Request for Class II Permissive Change

FCC ID: IYG97XX

- 1. Changed the model number from Versity 9753 to Versity 9740 for the marketing purposes.
- 2. Remove Scanner and Antenna changes. Changes do not affect the PCB layout.

Antenna changes detail

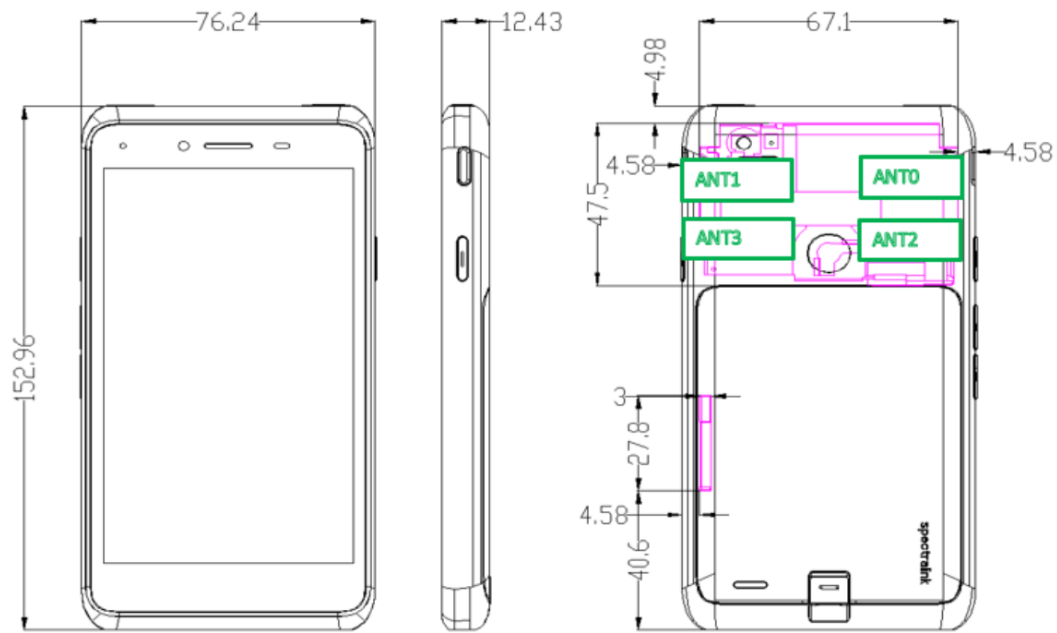
Versity 9753

Versity 9740
